## Service Bulletin

Bulletin No.: FRB-SB01

Ride: Fire Ball by KMG International, b.v.

Regarding: Start Signal to PCB.

**Manufacture: KMG Europe**  
**RE: Inspection Hole Crack**  
**Service Bulletin: FRB-SB03**  
**Date: October 2001**

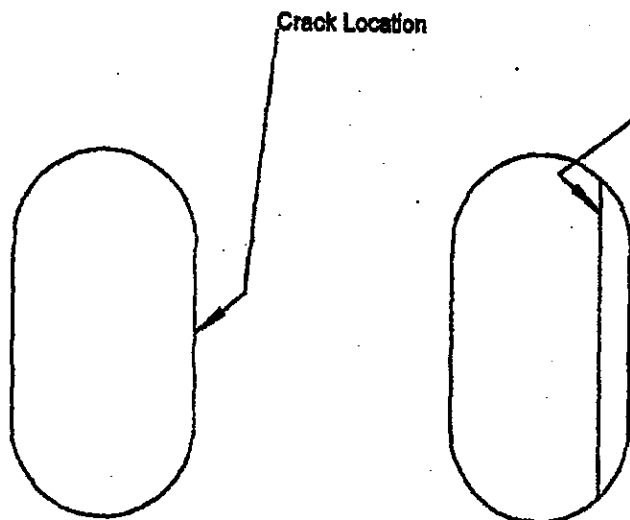
It has been determined through routine field inspections that a crack can develop at the location where the ends of the reinforcement bar meets inside the perimeter of the inspection hole. This is most likely due to an improper completion of the weld bead which can create a stress riser in the area.

Install gusset as shown on attached drawing.

**Gusset Material: 1" x 1/4" Bar, Cut to fit.**

**Preparation: Protect motor wiring and cover motor and hub bearing to prevent grind dust contamination. Remove paint from weld area.**

**Grind out existing crack. Reweld and grind smooth. Bevel weld edge of new gusset. Weld from top to bottom of gusset.**

**Use 7018 rod at highest setting possible.**

Picture SB04-1

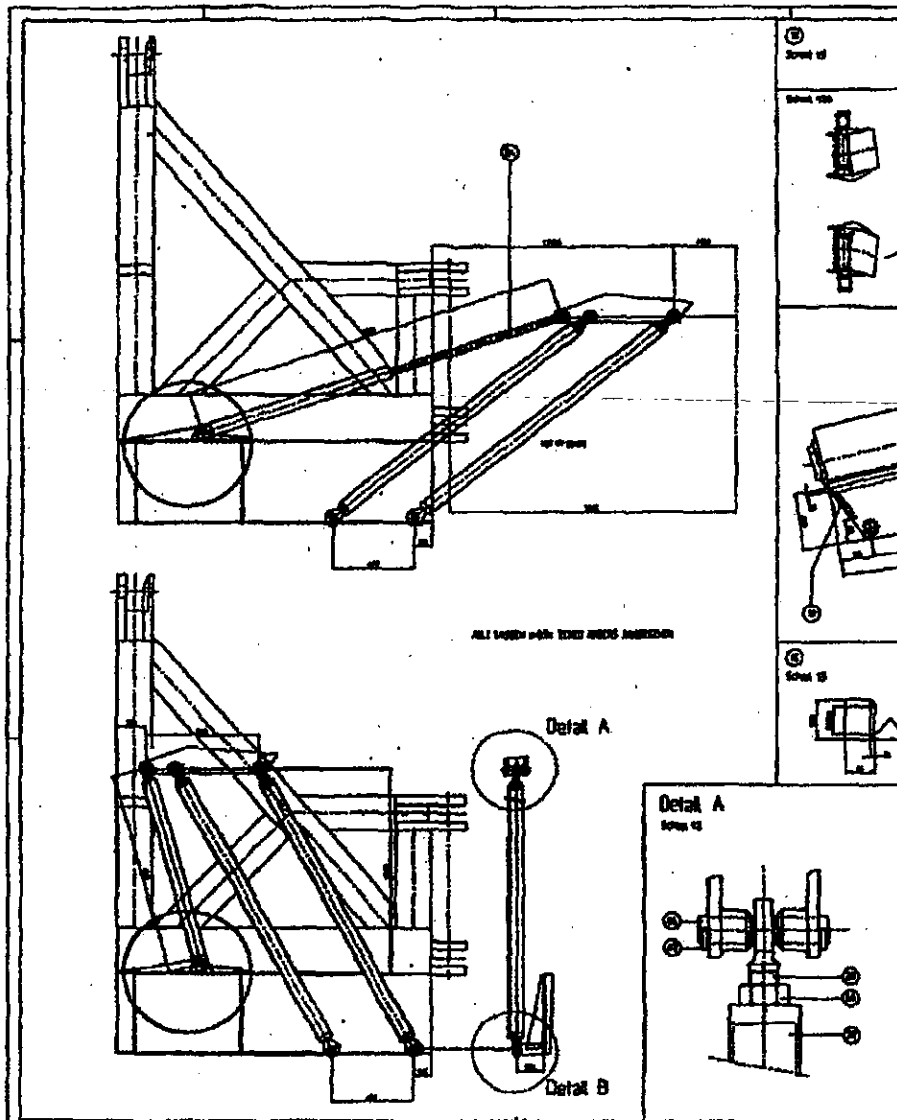
It has been determined through routine field inspections that a crack can develop at the base of the mounting plates at the bottom of each "Mast Out" hydraulic cylinder. See Picture SB04-1.

This is a Mandatory Service Bulletin, even if there is no crack detected during the visual inspection. Install the gusset modification as described in this bulletin before performing your next setup or tear down of the ride.
